RE: Gardens at North Carefree
PUD-18-001
Noise Impact Study
El Paso County, Colorado
LSC #174311

Figure 1
**Noise
Analysis Data**

Gardens at North Carefree Noise Analysis (LSC #174311)

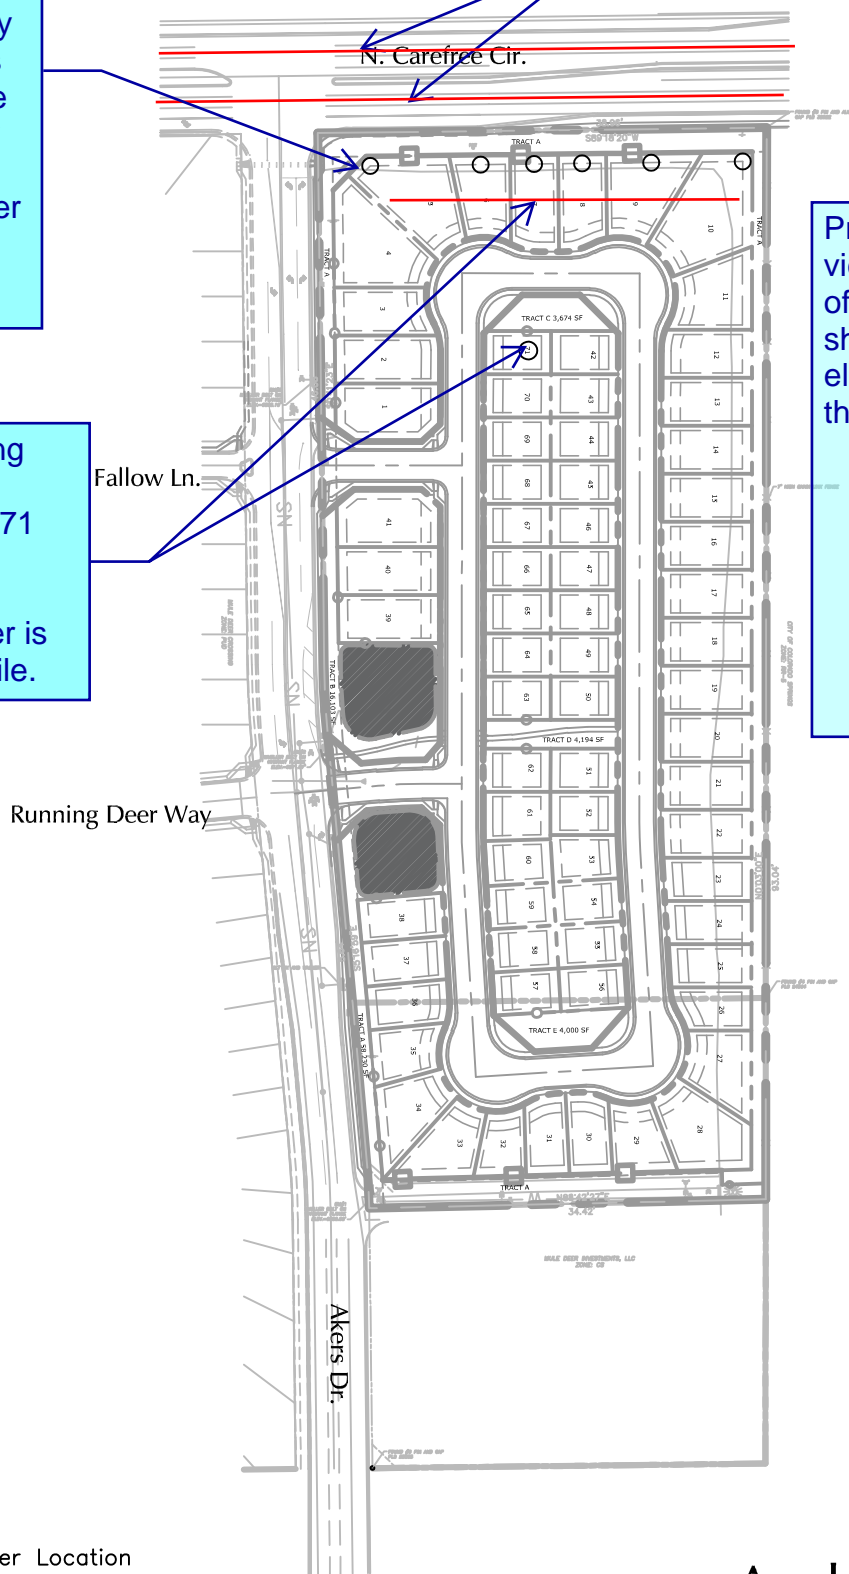
1. Label the receivers or increase the text size for the lots to be legible.

2. Callout the offset distance from the property line the receiver locations were modeled at. Per the grading plan the roadway slope extends past the property line. The receiver should be set back from the toe of the slope.

Show the roadway model location.

Provide a skew view/cross section of the model to show receiver elevation relative to the roadway.

1. Does a building row need to be modeled for Lot 71 receiver?

2. Lot 71 receiver is not in the input file.
